Item ID: D412-664-203TRN

Item Name: Crosstube Turning Detail

DART AEROSPACE LTD	Work Order:	10470+
Description: Crosstube Assembly (412 High Aft)	Part Number:	D412-664-243
Inspection Dwg: D412-664-243 Rev: E		Page 1 of 2

DRAWING NO. D412-664-243	TITLE CROSSTUBE ASSEMBLY (412 HI AFT)	REV. E	DART AEROSPACE LTD ENGINEERING ORDER		D.E.O. NO. D412-664-243-E-4	SHEET NO. SHEET 1 OF 3	SCALE NTS
DRAWN 47	CHECKED A	MFG. APPR. A	APPROVED MP		DE APPR. MP		
DATE 12.08.21	DATE 12.08.30	DATE 12.08.30	DATE 12/8/30		DATE 12.08-30

D412-664-243
ASSEMBLY DETAIL

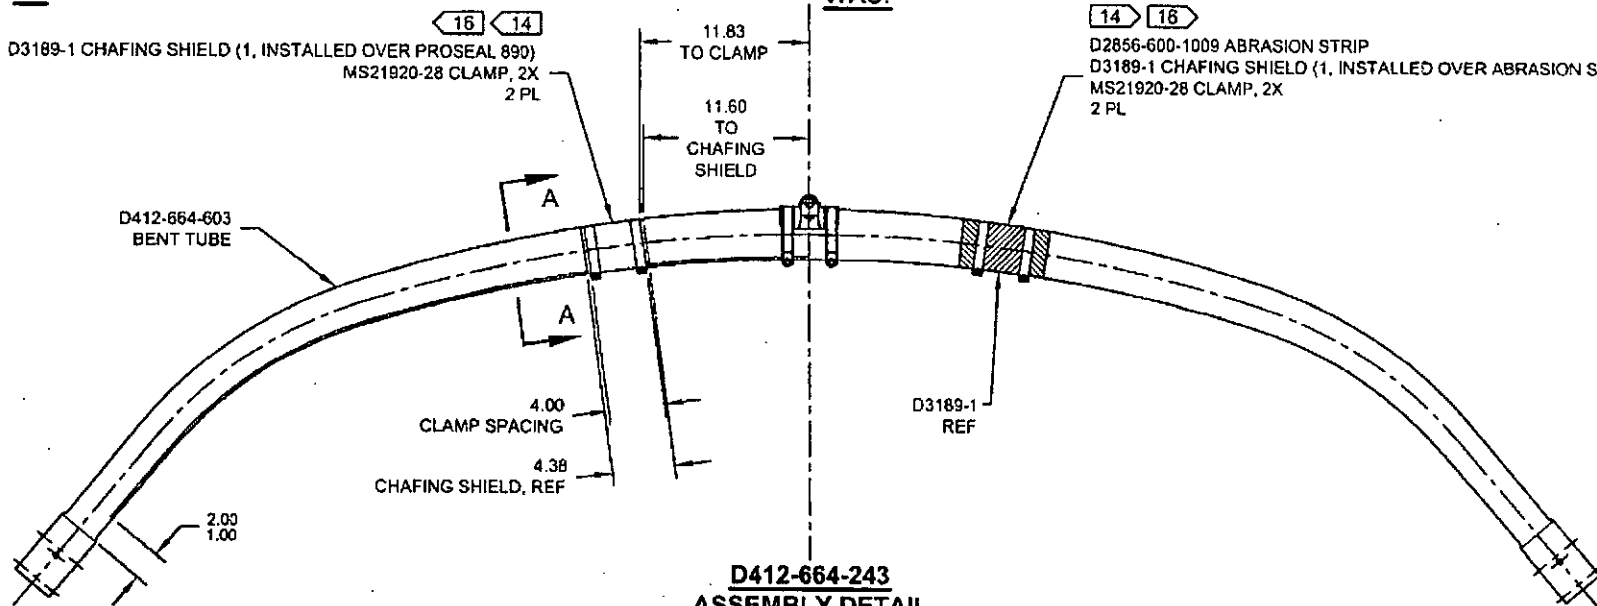
REMOVED ABRASION STRIP IN FAVOR OF A THIN LAYER OF PROSEAL 890. UPDATE INSTALLATION OF CHAFING SHIELDS AND REDUCE TORQUE TO 40-50 IN-LBS. THIS ENGINEERING ORDER SUPERCEDES DEO D412-664-243-E-1.

IS:

D3189-1 CHAFING SHIELD (1, INSTALLED OVER PROSEAL 890)
MS21920-28 CLAMP, 2X
2 PL

WAS:

D2856-600-1009 ABRASION STRIP
D3189-1 CHAFING SHIELD (1, INSTALLED OVER ABRASION STRIP)
MS21920-28 CLAMP, 2X
2 PL

MASK AREA PRIOR TO PAINTING AND
APPLY CLEAR COAT AFTER PAINTING

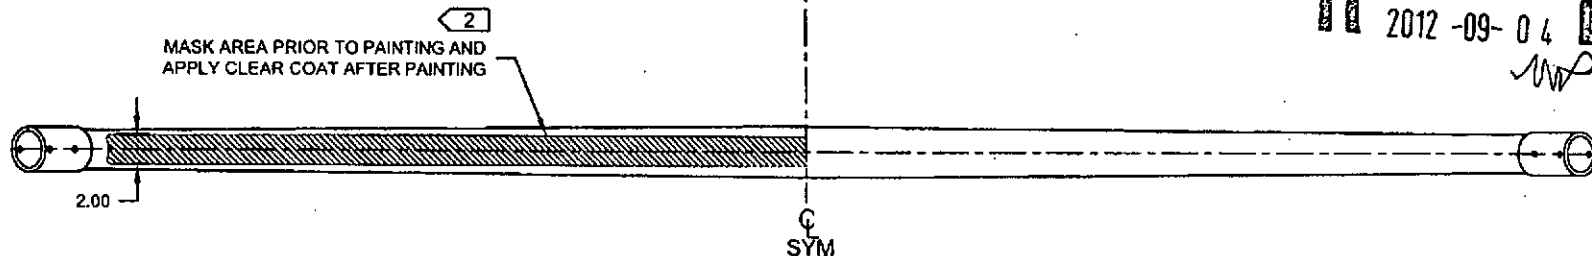
- 2) FINISH: CHEMICAL CONVERSION COAT PER DART QSI 005 4.1
PRIME INSIDE AND OUTSIDE PER DART QSI 005 4.2
MASK UNDERSIDE OF CROSSTUBE AS SHOWN (HATCHED AREA)
PAINT OUTSIDE PER DART QSI 005 4.2
AFTER PAINTING, APPLY CLEAR-COAT ON HATCHED AREA
- 14) APPLY A THIN COAT OF PROSEAL 890 ON INSIDE CONCAVE SURFACE OF D3189-1 CHAFING SHIELD AND LET CURE PER MANUFACTURER'S INSTRUCTIONS. INSTALL PROSEALED D3189-1 CHAFING SHIELD ONTO CROSSTUBE BY APPLYING A THIN COAT OF PROSEAL 890 ONTO CROSSTUBE. BE SURE TO ELIMINATE ANY AIR GAPS.
- 16) TORQUE CLAMPS ON D2896-1 SUPPORT 80 TO 100 IN-LB. **TORQUE CLAMPS ON D3189-1 CHAFING SHIELD 40 TO 50 IN-LB.** ENSURE AT LEAST 1.5 THREADS SHOWING IN SAFETY AND THAT NUT HAS NOT BOTTOMED-OUT AFTER TORQUING.
